ADA Curb Ramp New Construction Inspection Form (Parallel)

Nw 314th ave

24952.54

Nw. Kaybern st

PARALLEL RAMP (PL)

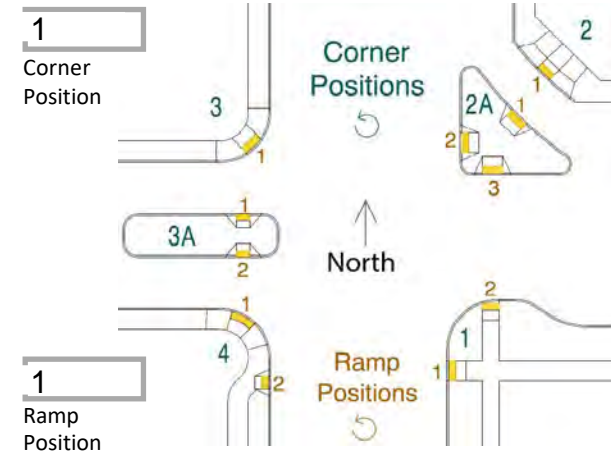
10.5 $\leq 2.0\%$ ☐ $> 2.0\%$ ☒

2.5 $\leq 2.0\%$ ☐ $> 2.0\%$ ☒

N Y ☐ N ☒

2.9 $\leq *$ ☐ $> *$ ☒

☐ 21.05 $\leq 8.3\%$ ☐ $> 8.3\%$ ☒

8.3 $\leq |5.0\%|$ ☐ $> |5.0\%|$ ☒

N Y ☐ N ☒

Comments:
No truncated dome, no RR2 or RR3
